INSTRUCTION TO SERVICE

ITS: 58450

SECTION:	246 AIR, BRAKE & LEVELLING SYSTEM.
WRITTEN BY:	Michael Rooney
SUBJECT:	Update compressor motor junction box wiring, lid and gasket.

Figure 1: Electrical Disconnect Switches.

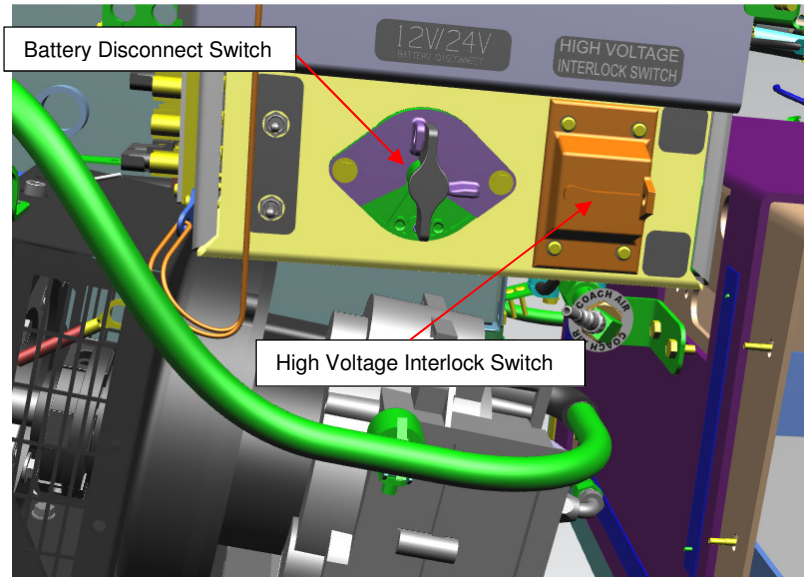
1. Open the access door at the curbside rear of the bus and locate the High Voltage Interlock Switch and Battery Disconnect switches. Figure 1.
2. Disconnect and lock out the High Voltage Interlock Switch. Figure 1.
3. Rotate the Battery Disconnect Switch to the off position. Figure 1.
